The City of Sedona, Arizona is issuing **Addendum #3** to the plans and specifications as originally issued at the time of solicitation for bids for the **PR-03c Ranger Station Improvements Project**. For any bid to be considered responsible and responsive, receipt of this addendum must be acknowledged.

This Addendum provides for revisions made to the project drawings and bid tab.

DRAWING NO. **C3**

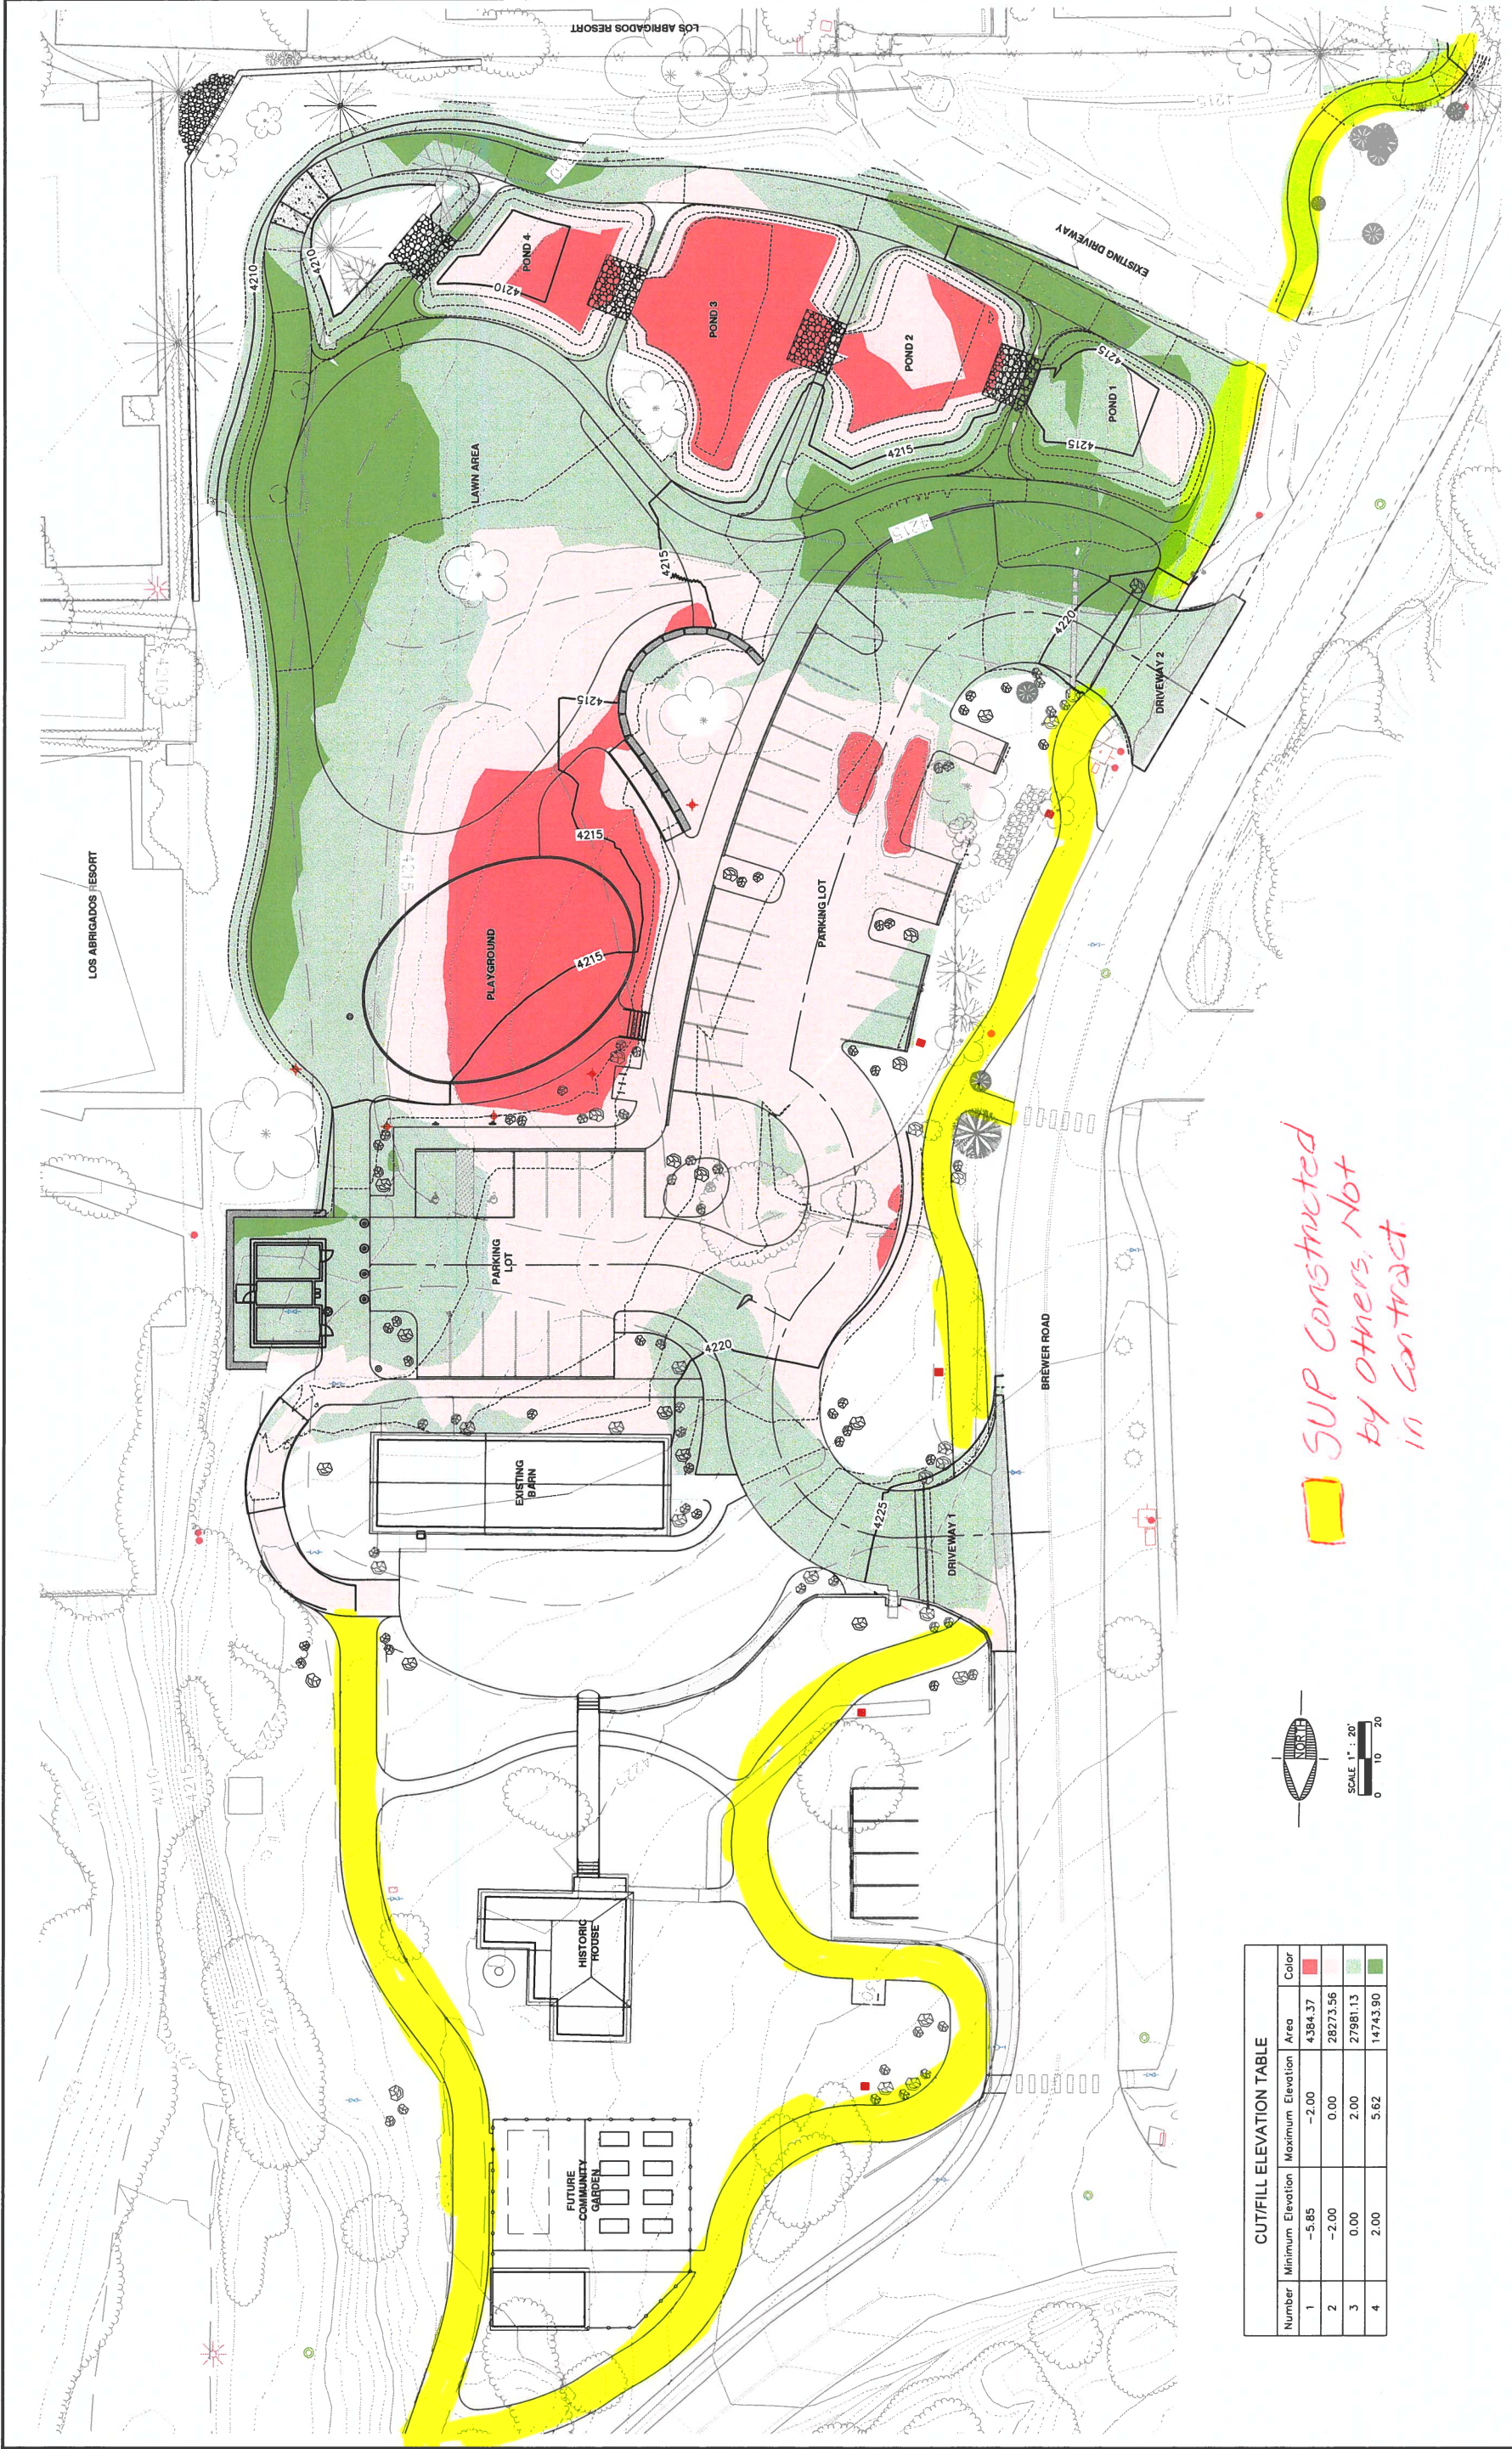
*SUP Constructed
by others, Not
in Contract.*
